City of Albuquerque

RE: DRAINAGE PLAN FOR AN ADDITION TO FURROW'S ON MONTGOMERY
(G-21/D31) ENGINEER'S STAMP DATED OCTOBER 15, 1991

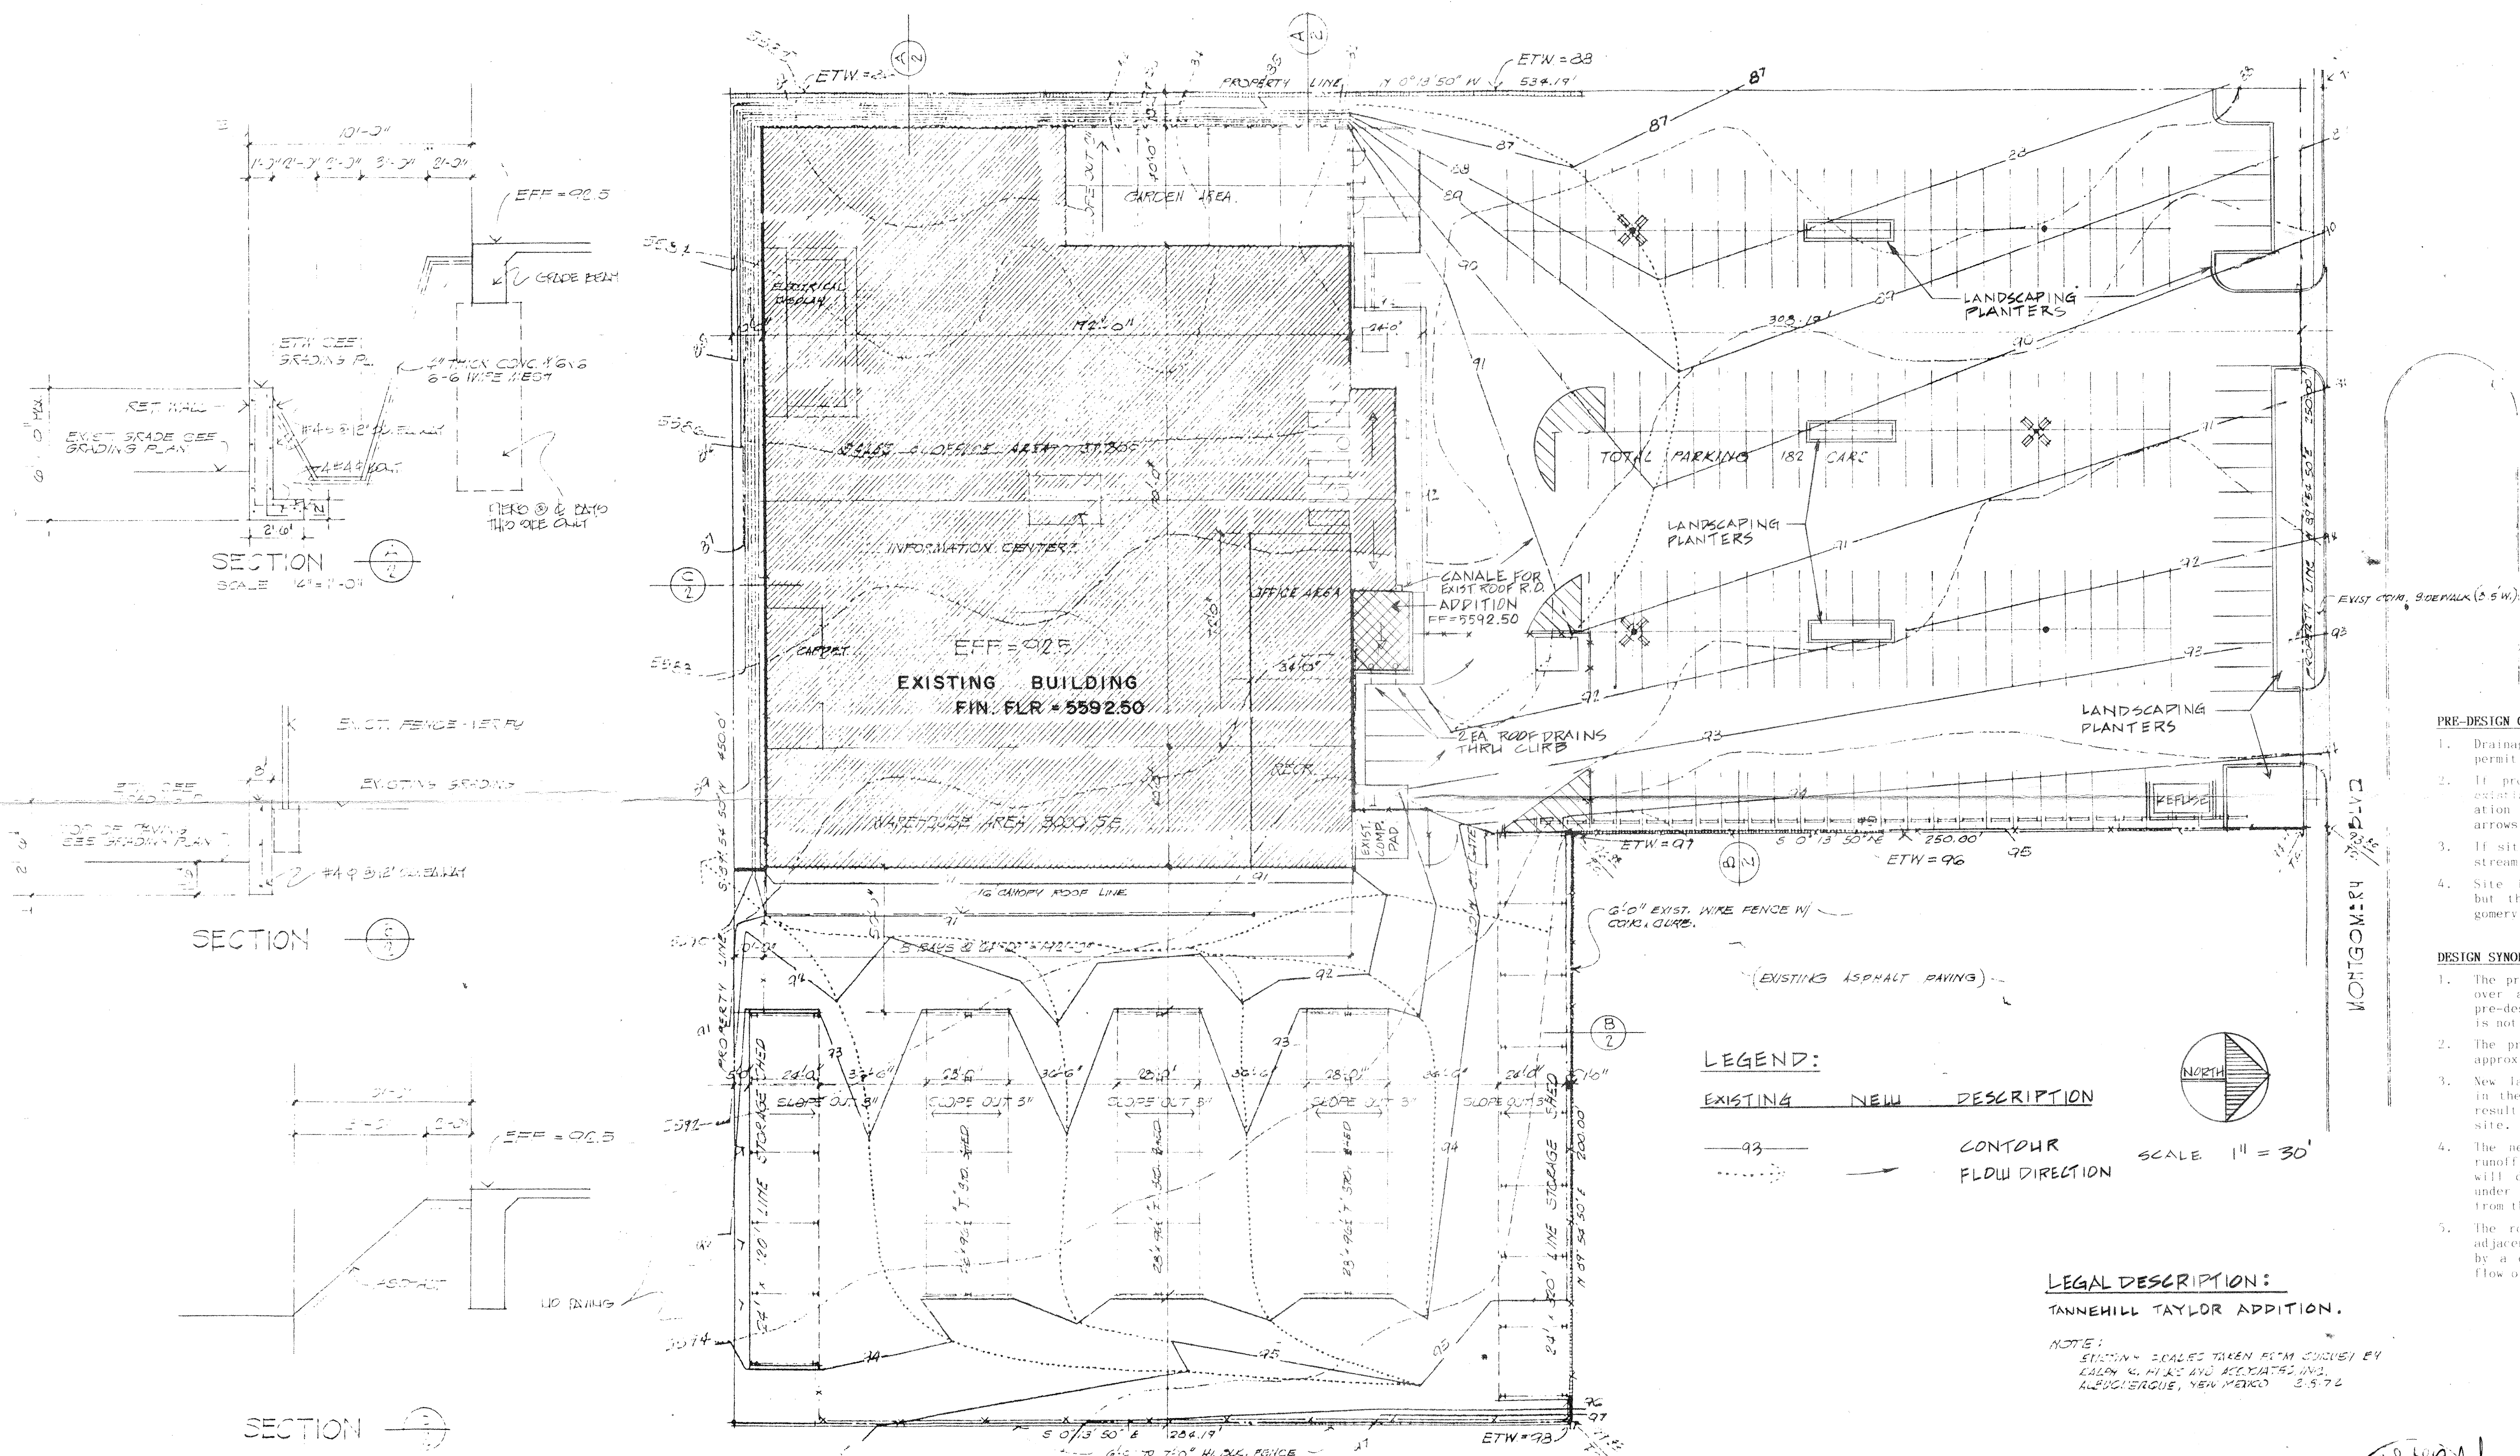
Based on the information provided on your submittal of October 15, 1991, the above referenced plan is approved for Building Permit.

Please attach a copy of this plan to the construction sets prior to sign-off by Hydrology.
